Subject: Adding Vehicular Entrances and Garage Doors to Historic Buildings

Applicable Standards: 2. Retention of Historic Character
9. Compatible New Additions/Alterations

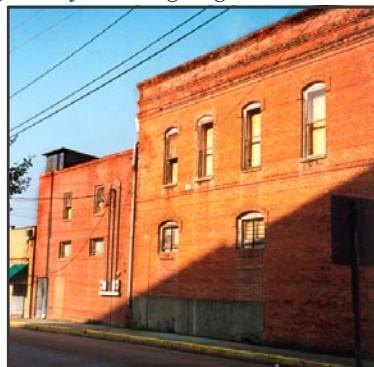
Application 2 (*Compatible location/Compatible treatment*): This Tuscan Revival-style building was constructed in 1912 as regional headquarters for a national company. The property was to be rehabilitated for apartments. The first floor of the more utilitarian wing added later, which had been used for parking company vehicles, was proposed to be used as parking for the residents. Although one garage door already existed on the side of the addition, another, slightly wider opening was needed to allow incoming and outgoing cars to maneuver around cars parked inside.

Since the property is situated on a corner, this side of the building is clearly visible. But, it is a secondary elevation and of considerably less importance than the primary façade. In this case, the existence of a garage door on this elevation was a factor in determining that adding another garage door would not greatly change the character of the historic building. A simple opening was cut into this wall and traditional paneled wood garage doors were chosen to complement the early-twentieth century style of the building. The completed project met the Standards.

Below: A wing was added to the right side of the headquarters building several years after it was constructed in 1912. Because this wing had always been used for parking and had a garage door on the side elevation (right top), adding another garage door was determined to be a compatible treatment (right bottom).
